MS Reference Number:	CSHK	CET	MS	С	2024	000115
ACC Reference Number:	1701	W	000	csc	760	000155

Method Statement for Installation of Sheet Piles for the Temporary Underfloor Wheel Lathe

Document Title: Method Statement for Excavation and Lateral Support for the Temporary Underfloor Wheel Lathe Document Revision: 22-Feb-24
Deadline: 28-May-24

Figure 1.1: Plan View of ELS at Temporary Underfloor Wheel Lathe and the Existing facilities

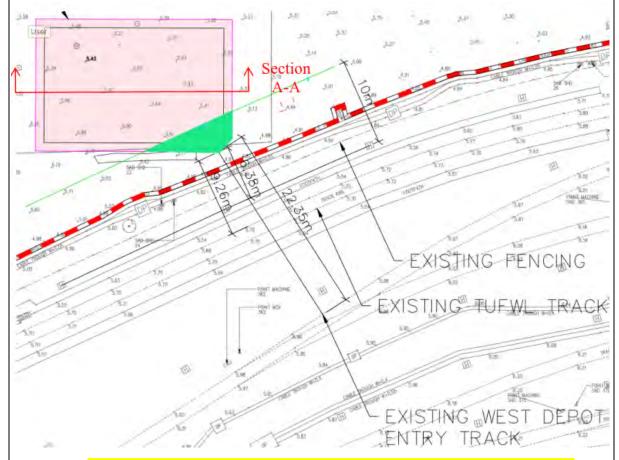
The plan view can be found in Section 7, Figure: Section and Plan of ELS at Temporary Underfloor Wheel Lathe and the Existing
21	Yu Sir	The Plan on Page 3	Where is the existing fence; OHL Masts and OHL? Please indicate it clearly on the Plan.	facilities in BIM Model and Point Cloud
22	Yu Sir	The Plan on Page 3	The distance of the sheet pile wall at various location to the existing fence, OHL Mast, OHL and track shall be clearly dimensioned on the	The plan view can be found in Section 7, Figure: Section and Plan of ELS at Temporary Underfloor Wheel Lathe and the Existing facilities in BIM Model and Point Cloud
23	Yu Sir	Para. 6 on page 6	Since the piling work will be carried out by using silent piler, what is the purpose of having a Vibrator?	Vibrator was removed from the plant list.
23	ruon	Turu. o on page o	one the pump work will be earlied but by doing shell pine, while to the pumpose of having a violation.	Total was removed from the plant hos.

Figure 7.7.1: Installation of Sheet Pile Stage from Phase 1 to Phase 4 indicated in figure above. The green lines identified the 10m area from the adjacent OHL or live track

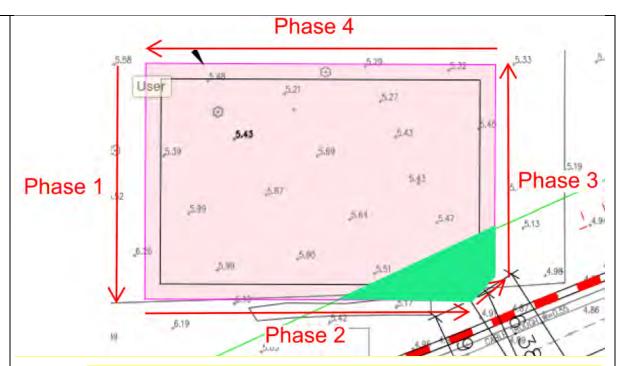
The figure 7.7.1 is updated to show the minimum extend of maximum 5m height sheet pile for your reference.
				TomUs Street
				har and a not an
	4 00		Figure 7.1.1 refers, please provide a layout plan showing the clearance between the sheet pile and railway facilities to justify the extent of	
	4 RP	-	5m height sheet pile.	2

Figure 7.7.3: Plan view showing the Distance between the silent piling machine set up location and one of the closest OHL posts are around 29 meters.

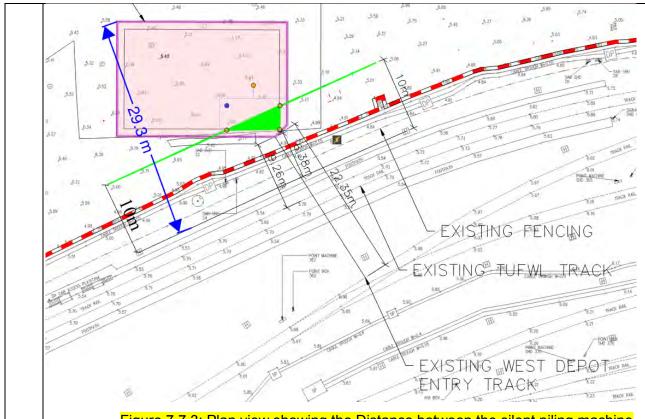
The setup location is around 29m, which is a screenshot captured in the Navisworks model and attached in Figure 7.7.3 for your reference.
5 RP -	The setup location of the silent piling machine and the relationship between the railway facilities shall be considered.	
6 RP -	PA works shall be applied when the sheet pile location was 10m measure from the railway facilities.	Noted. PA works will be input in ETMS system before commencement of work within 10m from the railway facilities if necessary. This sentence also added to section 7.7 Step 3 for clarification of the works.
7 RP -	Appendix D, proposed TUFWAL lifting plan (stage 1) refers, the operation zone for the 32T crane lorry was found intruded into the existing railway facilities which is not acceptable. The jib length shall be specified. The lifting capacity of the crane lorry shall not exceed 80% of SWL. Section showing the critical lifting works shall be provided. The collapse path of the lifting works shall not intrude to the railway facilities.	3. Crane lorry lifting chart and the corresponding Safe Working Load (SWL) (WITHIN 10M ZONE FROM OHL POST) Lifting Dean No. Lifting Objective Description Sheet Pile  Sheet Pile  0.3 for  Lifting Plan for Lifting a Type 3 Sheet Pile 5m MODEL: F990RA.2.28 (FASSI, ITALY) BOOM LENGTH: 19.85m WORKING RADIUS: 9.65m @ S.W.L.=7.715T WEIGHT OF LIFTING OBJECT: 0.3T (CRITICAL CASE) WEIGHT OF LA/LG: 0.3T TOTAL WEIGHT: 0.3+0.3=0.6T LIFTING CAPACITY: 0.6T/7.715T=8%  3. Crane lorry lifting chart and the corresponding Safe Working Load (SWL)  Lifting Plan for Lifting a Type 3 Sheet Pile 12m MODEL: F990RA 2.28 (FASSI, ITALY) BOOM LENGTH: 19.85m @ S.W.L.=3.255T WEIGHT OF LIFTING OBJECT: 0.72T (CRITICAL CASE)

38	Yu Sir		1. Figure 7.6.2 on page 21 of 47 : Please mark up the 10m line (10m from the adjacent OHL/live track) on the plan.	Noted. The 10m line is marked in Figure 7.6.2 for your reference.    Tam(H) Sheet   Pile   Pi
39	Yu Sir		<ol> <li>Figure 7.7.3 &amp; &amp;.7.4 on Page 24 of 47: The mentioned 29m distance is misleading. The closet distance between silent piling machine and the OHL Posts shall be measured from the SOP03.</li> </ol>	This figure mainly responds to Rtc No.5 regarding the setup location of the silent piling machine. For the entire sheet pilin installation works, the silent piling machine can handle the corner works without requiring any lifting during the installation of the corner sheet pile. Therefore, there is only one designated setup location, SOP01, which aligns with figures 7.7.3 and 7.7.4.
